ORANGE COUNTY WATER DISTRICT
18700 Ward Street
Fountain Valley, California 92708

ADDENDUM NO. 4
TO
CONTRACT DOCUMENTS
FOR
CITY OF SANTA ANA
PFAS TREATEMENT AT JOHN GARTHE RESERVOIR
CONTRACT NO. SA-2025-1
11/5/2025

D D3101 WELL 39 DISCHARGE PIPING SECTION
SCALE: 1/4"=1'-0"

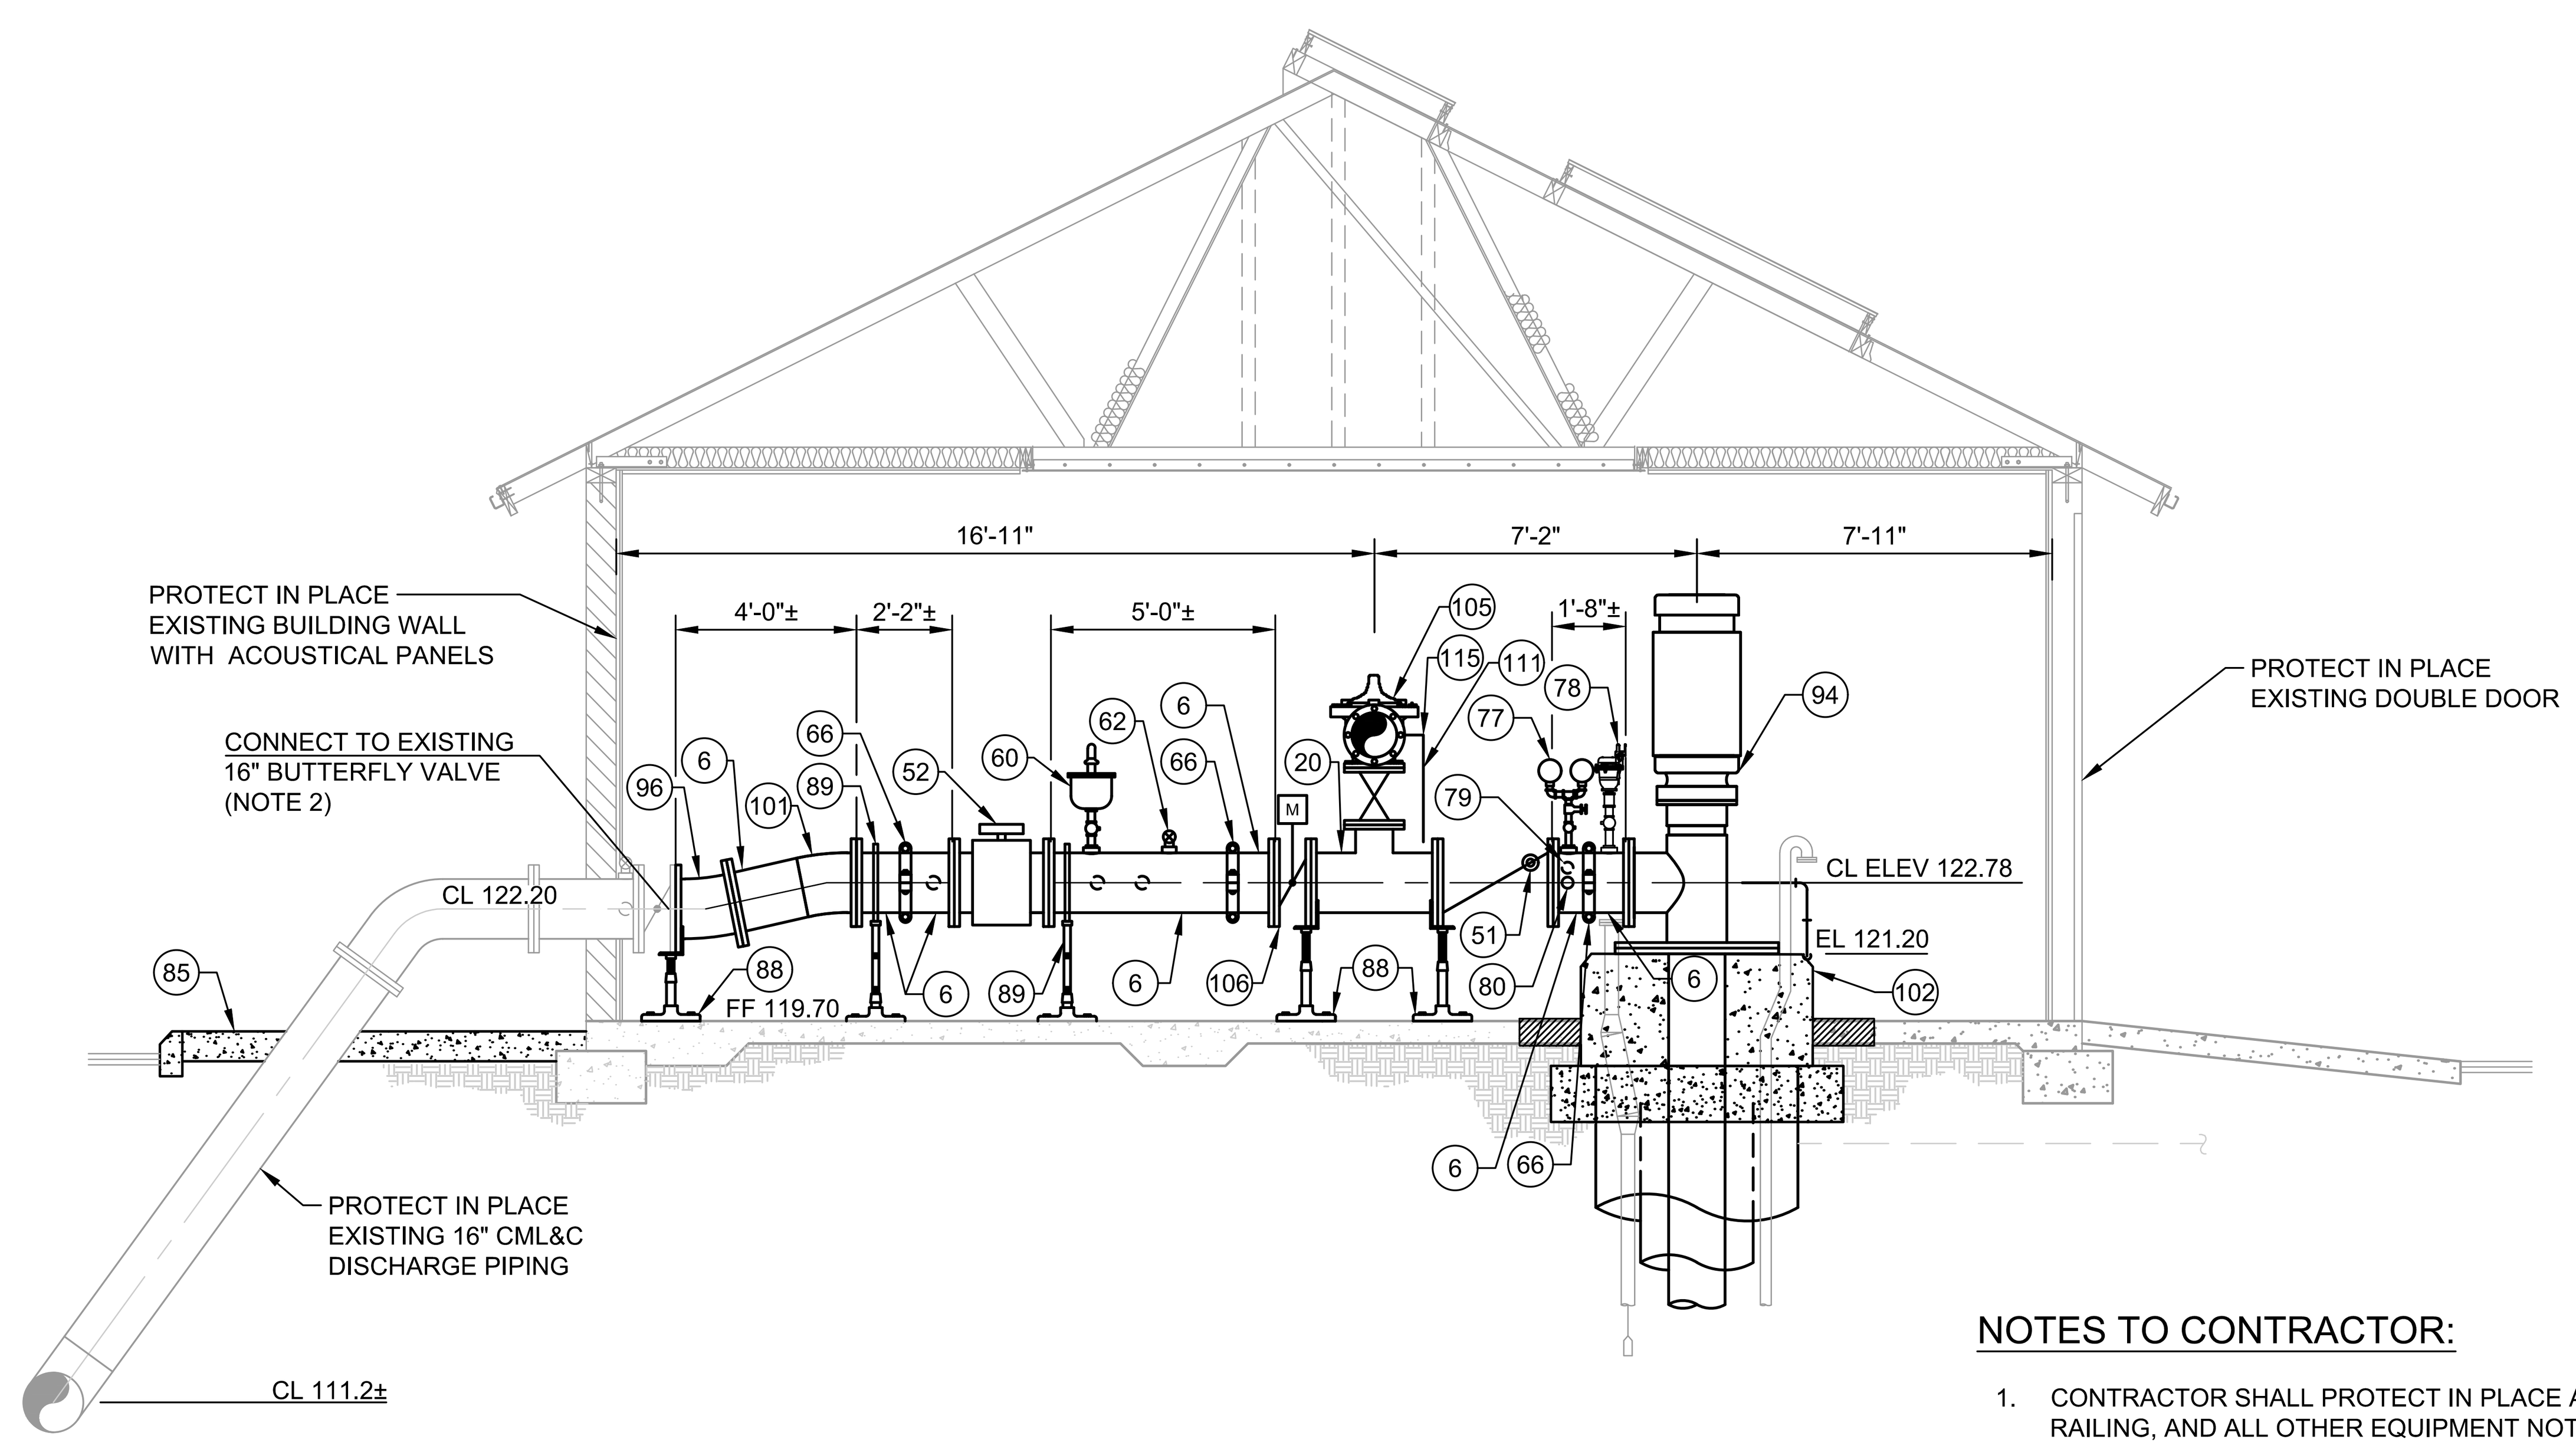
32	11. Please clarify what is intended to be entered into Bid Item #10 – Above Grade Pipe, as the other bid items in the IX area, OSHG building, Well building, Sand Filter, etc also state that they are to include the pipe.	Bid Item #10 is for all above grade piping that is not included in another specific bid item.
33	Drawing D0501 – Pre-Lube Assembly Backflow Preventer: Detail 8 on Drawing D0501 shows a backflow preventer in the pre-lube assembly. Since a backflow preventer already exists on the copper supply line, please confirm whether the additional backflow preventer is required.	Backflow preventer shown in detail is required - bid per plan.
34	• Drawing D0301 / D3302 – Coupling Type Clarification: Construction Note 68 on Drawing D0301 specifies a flexible coupling, while Construction Note 66 on Drawing D3302, Section D, indicates a grooved coupling at the same location. Please confirm which coupling type is correct.	Plan sheet D3101 has been revised to reflect Construction Note 66.

35	• Drawing D3101 – Port at 2" Air/Vac Assembly: On the Well 39 discharge piping shown in Drawing D3101, there is a port near the 2-inch air/vac assembly that is not labeled. Please confirm if this is intended to be a 1-inch flow meter test port.	This tap is a 2" spare pipe tap. Plans have been revised to show construction note 62.
36	Drawing D3101 / D3302 – Hydro Generator Pipeline Supports: Drawing D3101 shows three pipe supports on the 16-inch hydro generator pipeline, while Drawing D3302, Section B, shows only two supports. Please confirm the correct number and spacing of supports.	D3101 is correct - D3302 has been revised to reflect the three pipe supports.
37	Pipe Schedule: The bid documents (Construction Drawing, Specifications and Pipe Schedule) call for Schedule 80 PVC for the double containment carrier pipe, however, the construction notes calls for CPVC. Please clarify.	Construction notes will be updated for the sodium hypochlorite to call out PVC.
